Five-Year Review Report
Fourth Five-Year Review Report
For
FMC Corporation (Fridley Plant)
Fridley
Anoka County, Minnesota

September, 2009

Minnesota Pollution Control Agency
St. Paul, Minnesota

As Modified by
The United States Environmental Protection Agency
Region 5
Chicago, Illinois

Cross Section B-B'
2007 Trichloroethene Concentrations
Former FMC Site
Fridley, Minnesota

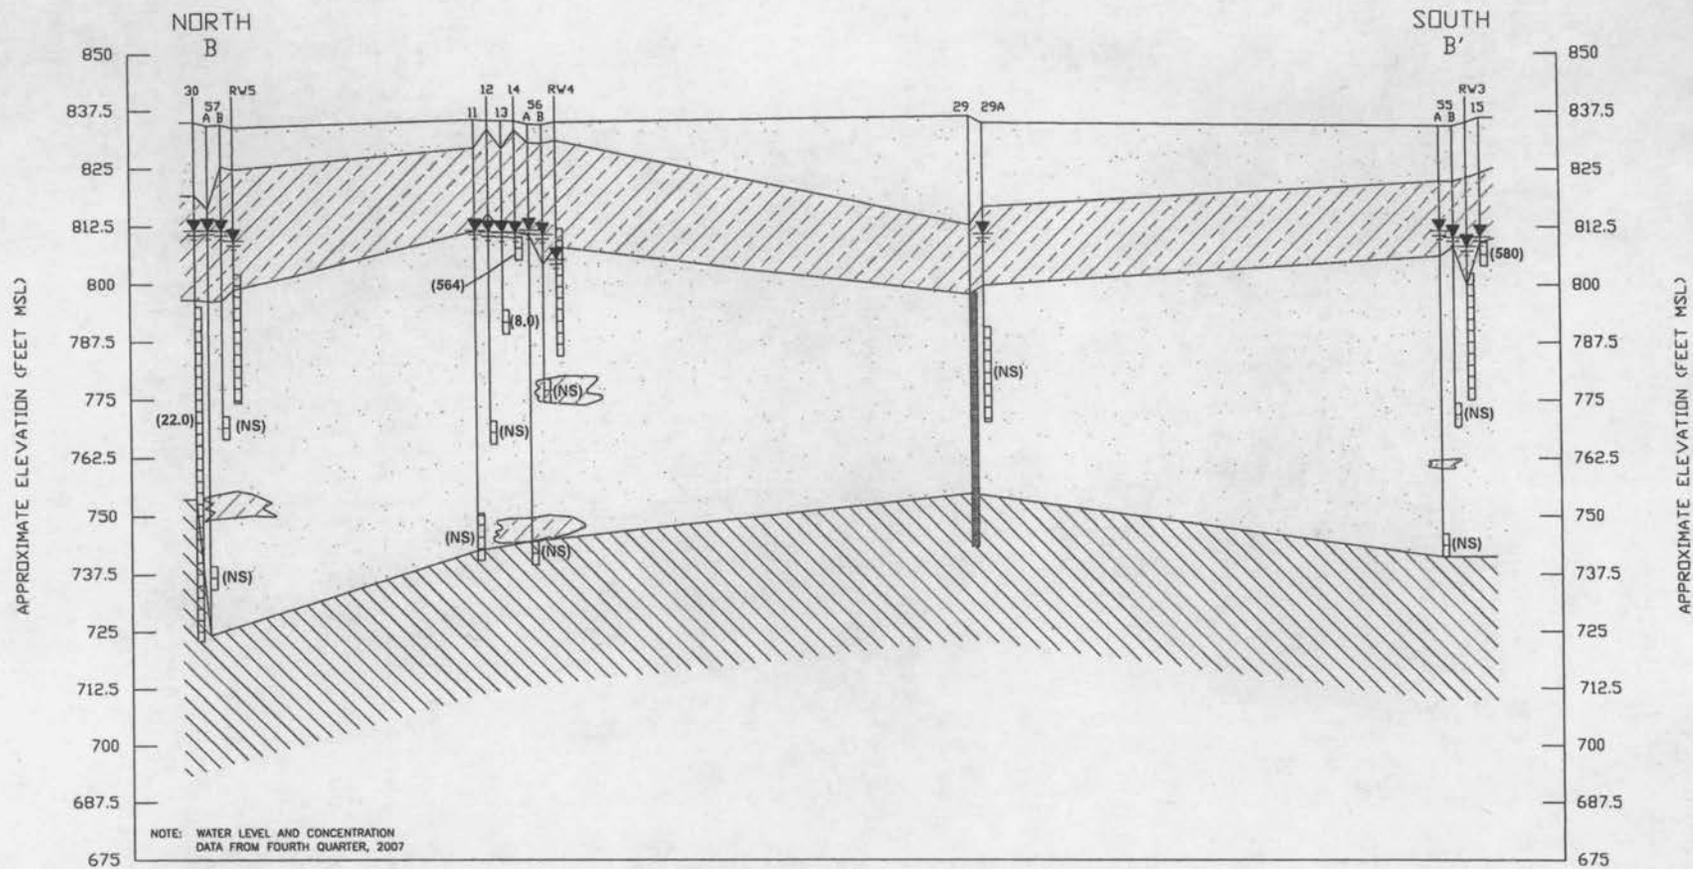
Cross section B-B' from the 2007 AMR should be expanded to include information from the BNR portion of the site. Detail should also be provided to identify the depths and location of previously excavated areas of the Site relative to groundwater elevations. Possible contaminant migration pathways through the confining clay layer may be present in the previously excavated areas. An accurate cross section could identify possible areas where these migration pathways may be present.
